Shell Cove Boat Harbour Precinct (MP07_0027)

Preferred Project Report

November 2010

Figure 3: Street Network

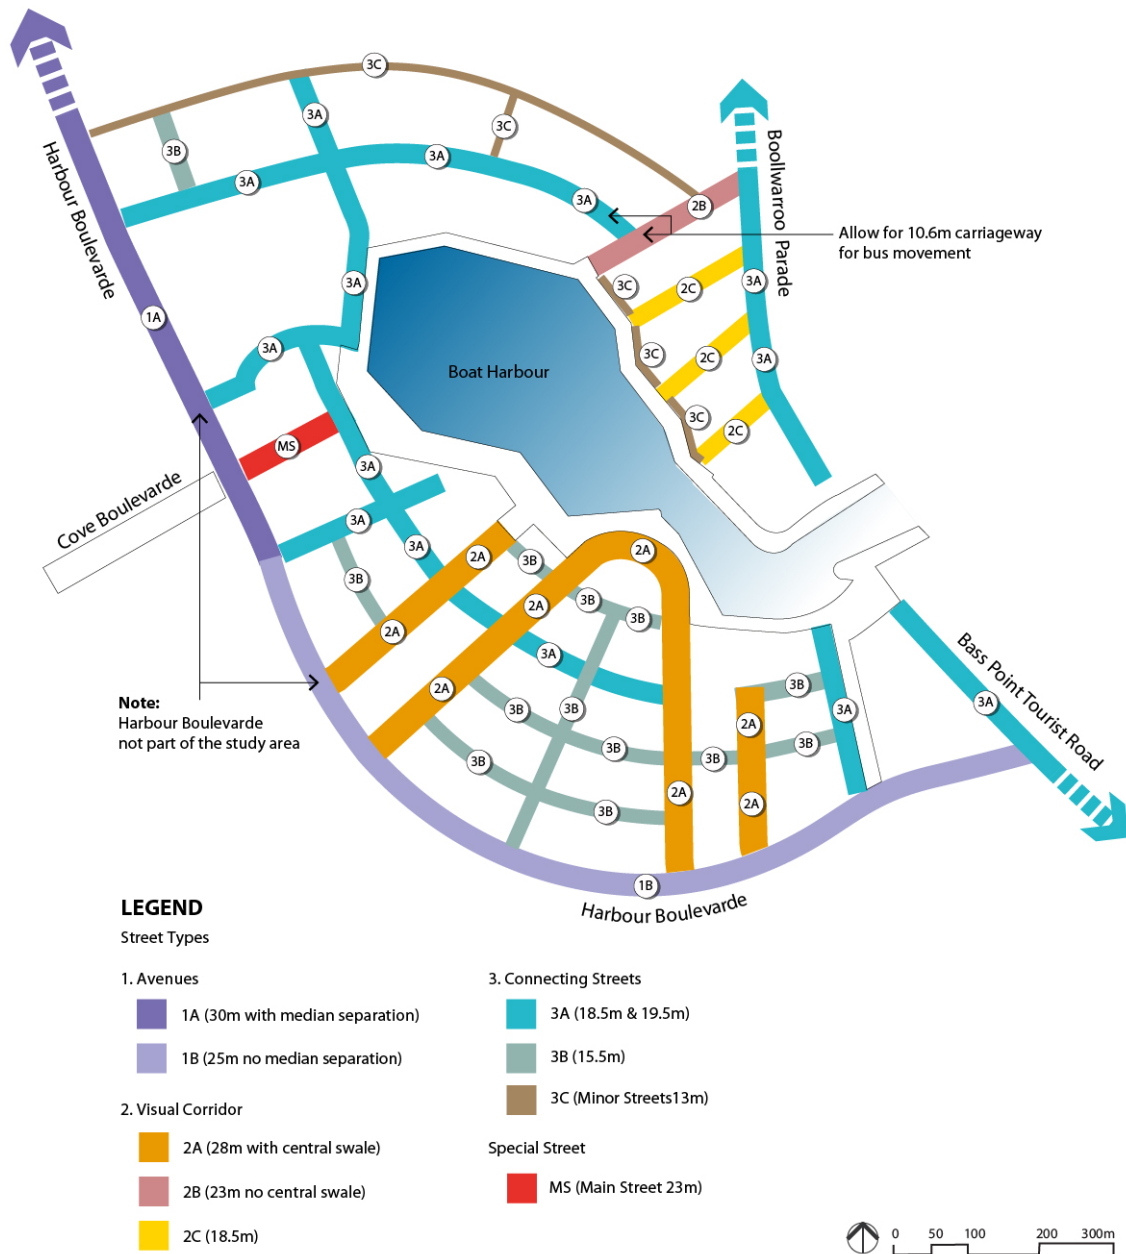
A detailed review of the street network and street types has been undertaken and the hierarchy simplified. Refer to **Figure 3**.

For the Boat Harbour Precinct, the approach has been to create a range of street types related to both traffic functions and visual/landscape character. Four types of streets are proposed including Avenues, Visual Corridors, Connecting Streets and Special Streets (Main Street/Conceptual Laneway). Within each category there are minor variations which are specific

to the location e.g. different land use, edge condition, median and water sensitive urban design (WSUD) principles. Refer to **Tables 3, 4, 5 and 6**.

Figure 4: Open space

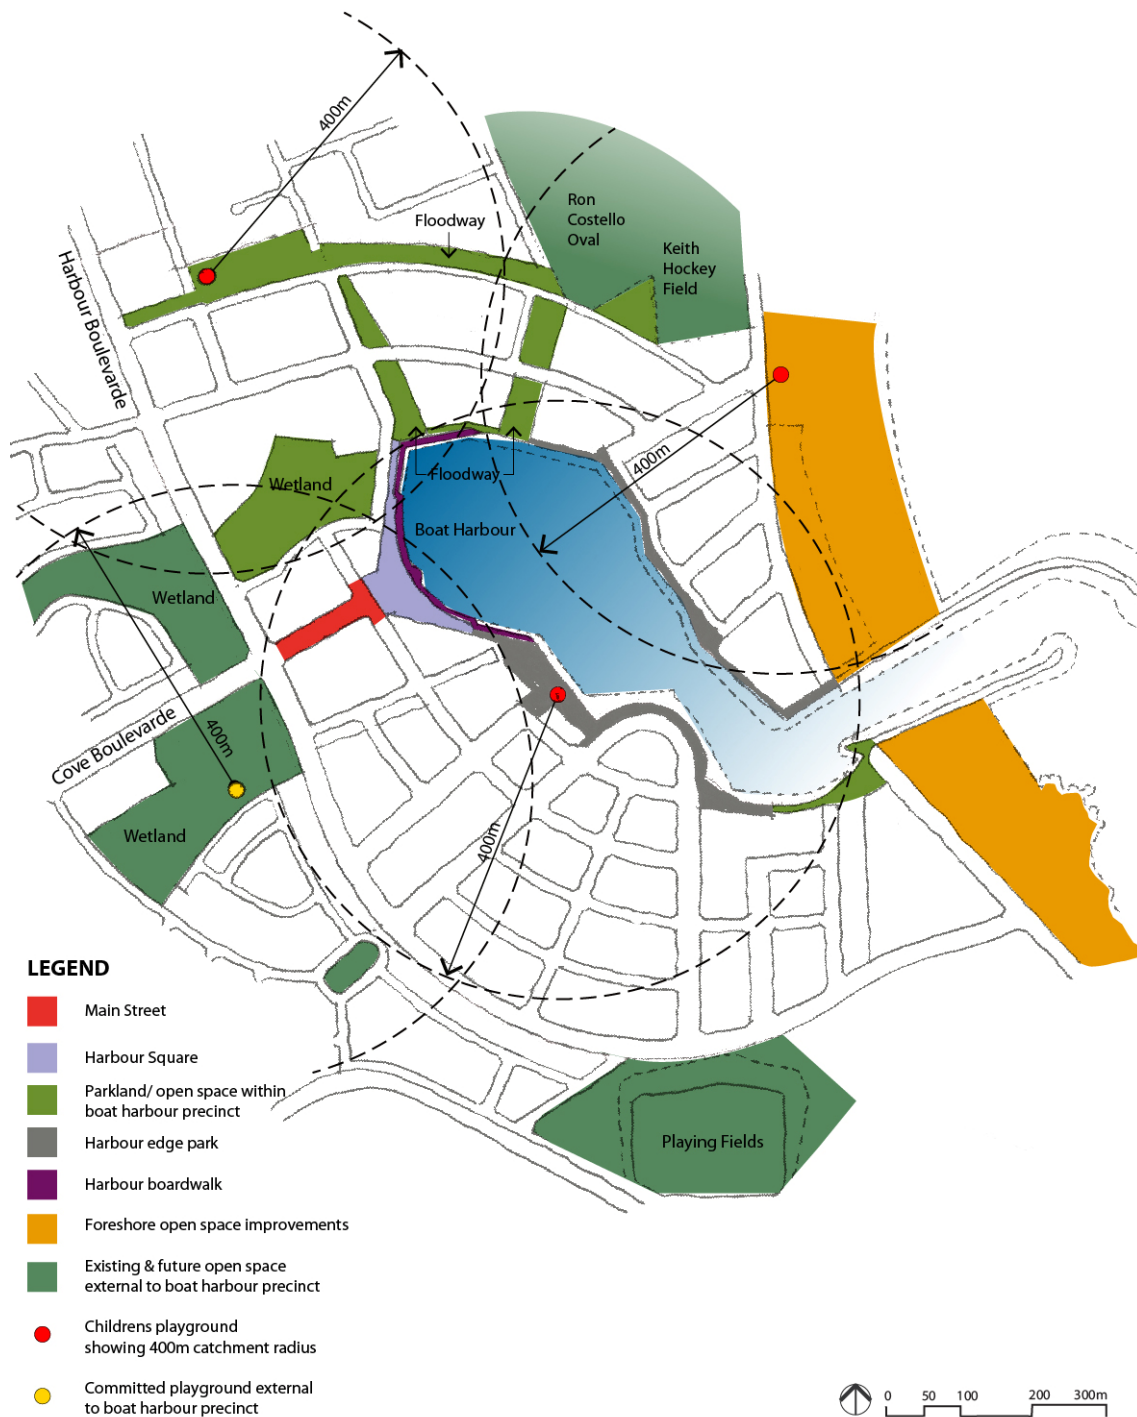
Figure 4 shows the open space network including the location of three proposed Shell Cove playgrounds (as requested by DoP).

Figure 4 shows four proposed playgrounds and the relevant 400m walking distances, as well as adjacent open space and playing fields. The drawing indicates a high level of access to open space facilities. The plan also shows the water edge walkways.

Figure 5: Bus routes and 400m catchment area

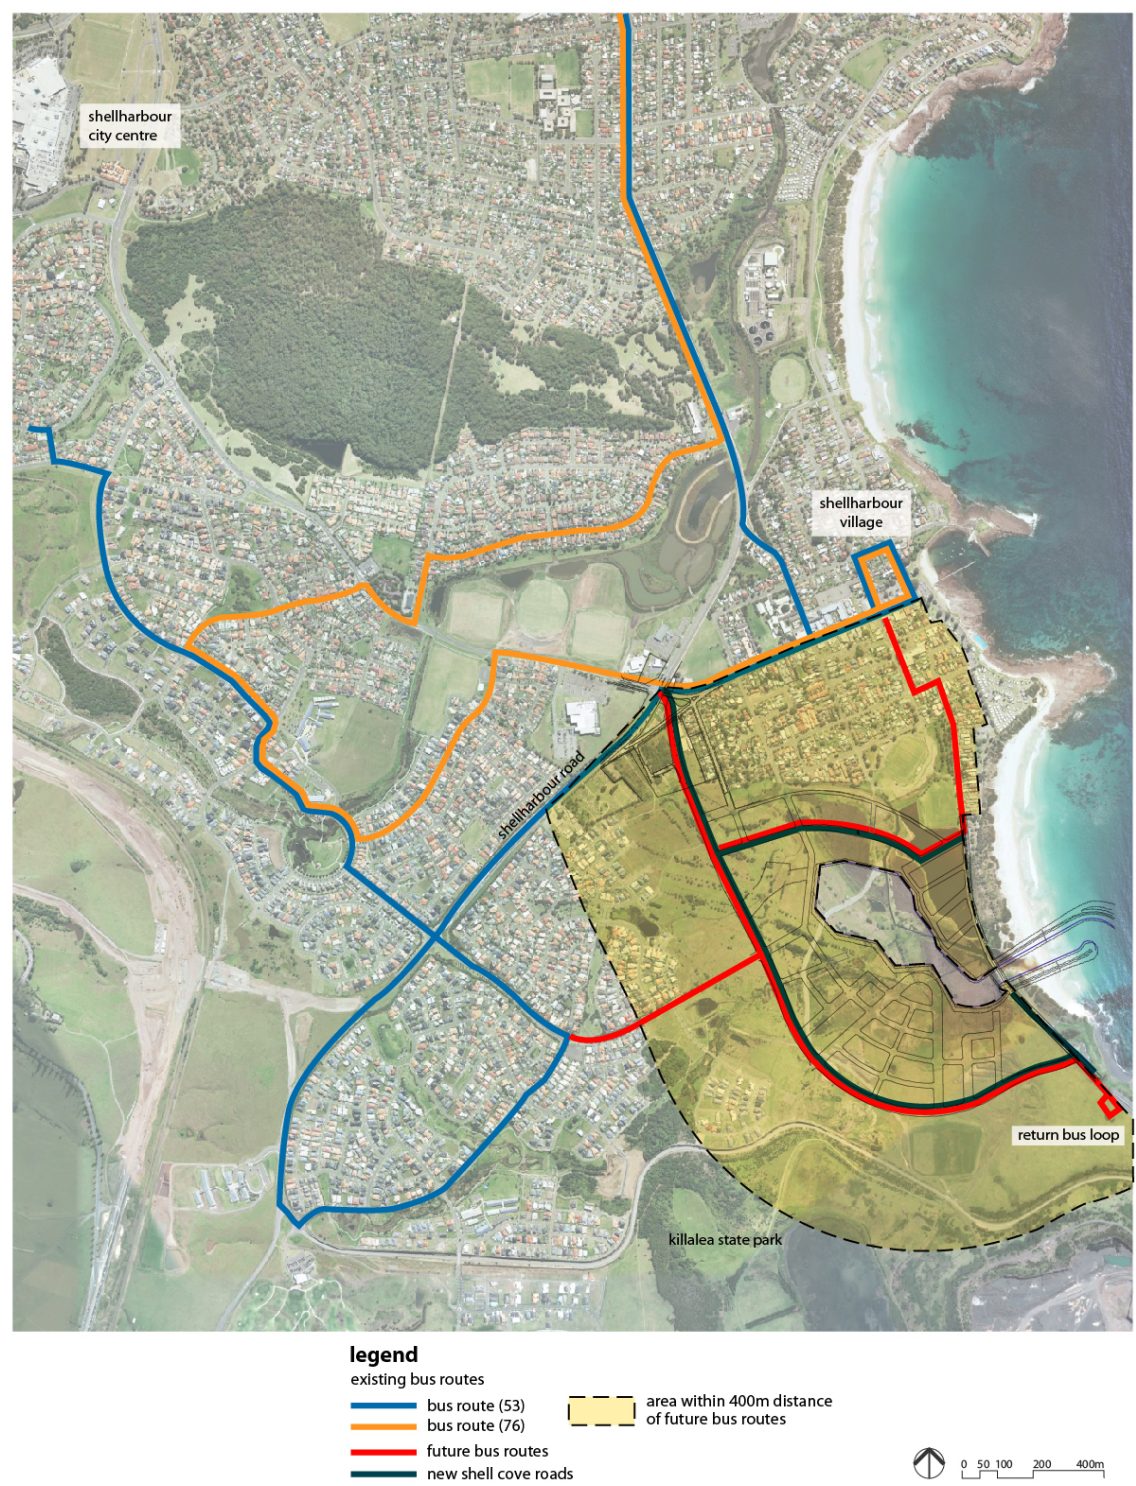
Figure 5 indicates the pattern of existing and future bus routes for Shell Cove and indicates that the majority of residents will be within a 400m walking distance of a bus route.

The provision of bus routes and bus stops in the Boat Harbour Precinct will contribute to the target; with bus stops located within a 400m walking distance from the majority of future residents (at least 85%). Refer to **Figure 7** in Section 3.3.4.

Figure 7: Beach erosion and shoreline recession hazard zones in immediate period (SMEC, Appendix D, Figure D.25)

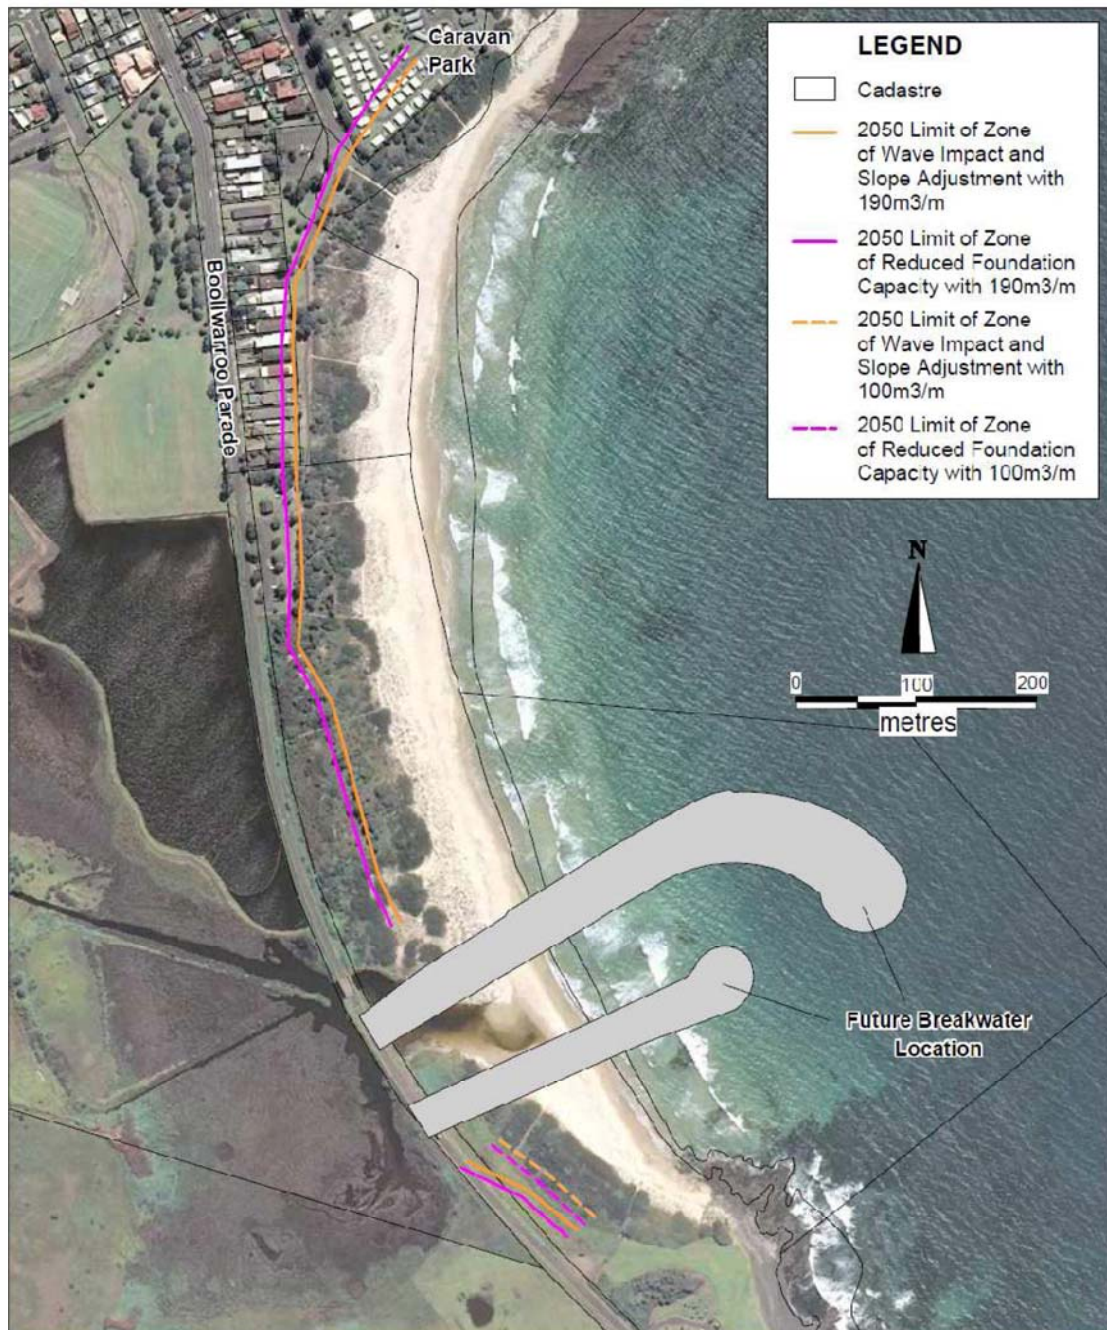
Two submissions raised the issue of mapping the beach erosion and shoreline recession hazard lines for the present time, 2050 and 2100:

- The submission by Shellharbour City Council highlighted the need to include mapping of the Zone of Reduced Foundation Capacity and Stable Foundation Zone as well as the usual Zone of Wave Impact and Zone of Slope Adjustment. The submission also made reference to the Shellharbour Coastal Hazard Study prepared for Council by SMEC (2010) and the desirability of using this Study, rather than the hazard assessment in the Environmental Assessment, for purposes of determining planning and development controls for the Shell Cove Boat Harbour Precinct development.
- The submission from DoP, which relied upon the report prepared by its external consultant Parsons Brinckerhoff.

- north of the proposed Boat Harbour entrance:
 - the limit of the Zone of Reduced Foundation Capacity in the immediate, 2050 and 2100 planning periods are all seaward of Boollwarroo Parade
- south of the proposed Boat Harbour entrance:
 - the limit of the Zone of Reduced Foundation Capacity in the immediate, 2050 and 2100 planning periods, for a storm bite of $100\text{m}^3/\text{m}$, are all seaward of Bass Point Road.

The SMEC (2010) study therefore demonstrates that development within the Shell Cove Boat Harbour Precinct landward of Boollwarroo Parade / Bass Point Tourist Road would not be impacted by beach erosion and shoreline recession hazards up to the planning period of 2100.

Figure 16: Social infrastructure outside of Boat Harbour Precinct

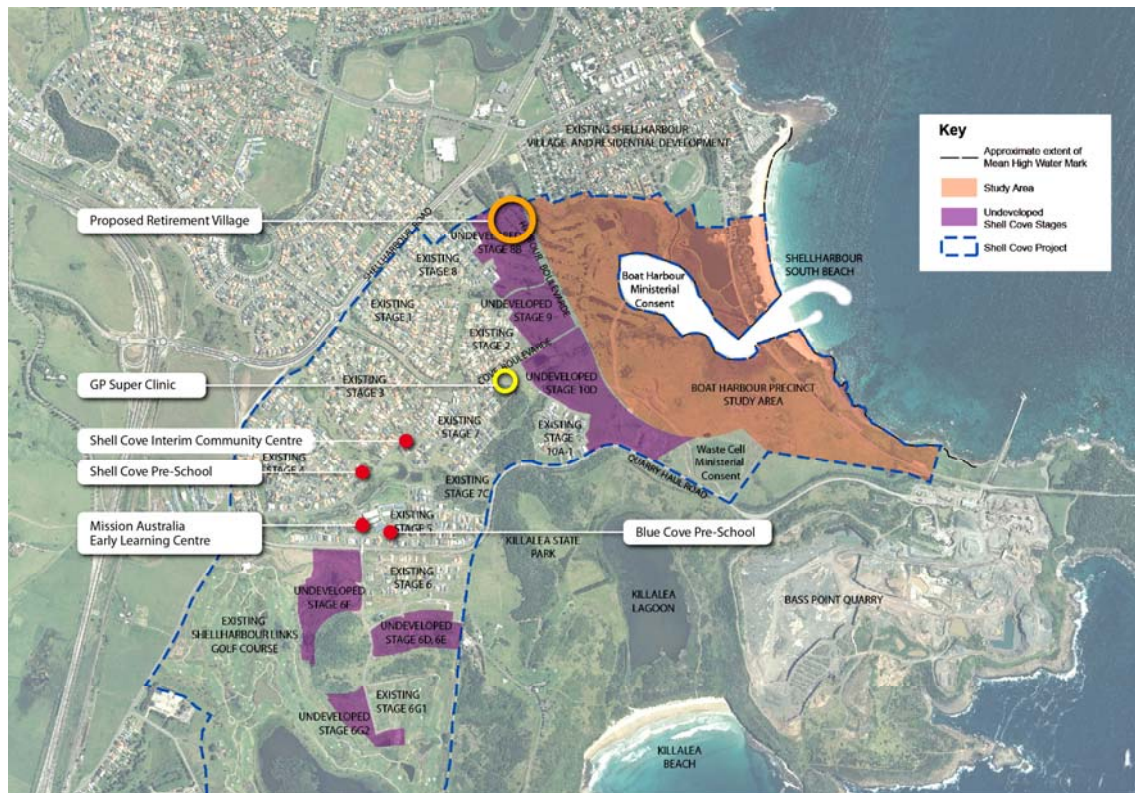
Issues raised in relation to the provision of housing and social infrastructure by Shellharbour City Council, Illawarra Greens and DoP have been considered in the context of the wider Shell Cove area.

In addition to the social infrastructure proposed in the Concept Plan for the Boat Harbour Precinct, a number of other facilities including seniors living, child care centres and a GP super clinic will be provided as part of the overall Shell Cove project, which will also serve Boat Harbour Precinct residents. Refer to **Figure 16**.

Figure 17: Pedestrian and cycle access to Killalea State Park

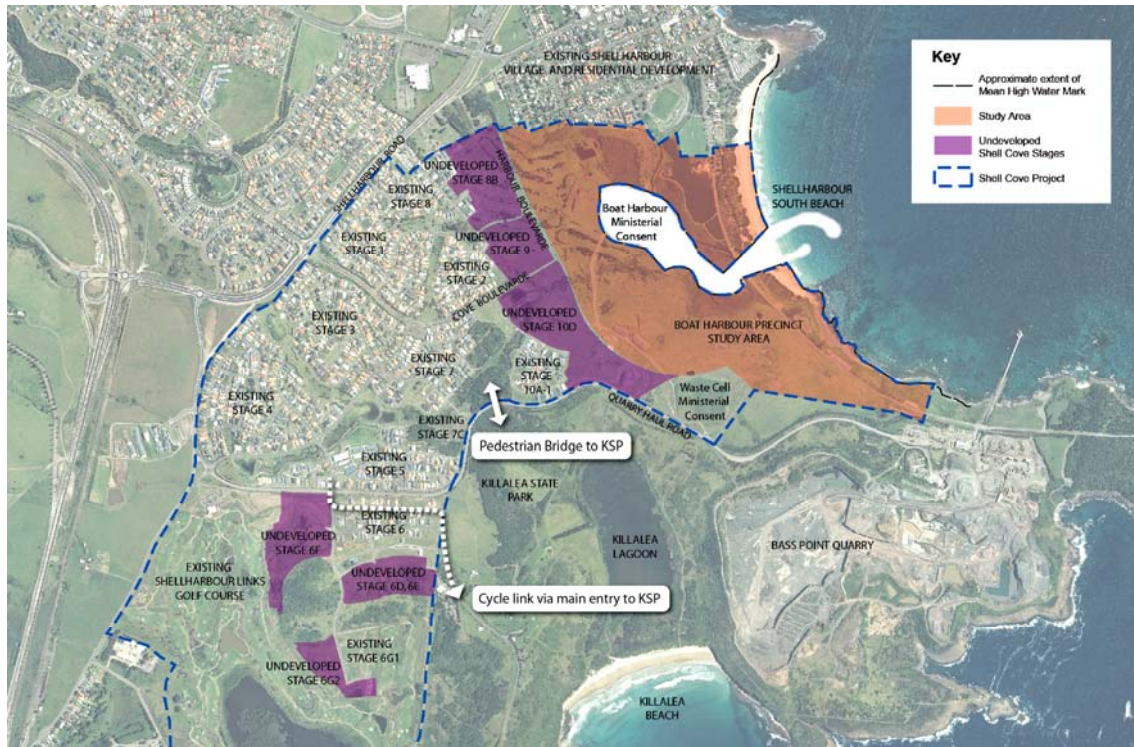
There are currently two points of access to the Killalea State Park (KSP) via the Shell Cove project. Refer to **Figure 17**. These include the main entry off Killalea Drive and a pedestrian bridge across the quarry road in the vicinity of Hinchinbrook Drive. These access points are consistent with the 2000 Structure Plans endorsed by Council.

Discussions with the KSP Trust have been previously held and it is noted that the KSP holds a firm position that no further points of access into the KSP will be permitted. This position is premised on the Park's need to control access into and out of the KSP.

A long-term strategy to provide a coastal walk connection to the KSP from Bass Point has been developed separately by Council and the KSP.
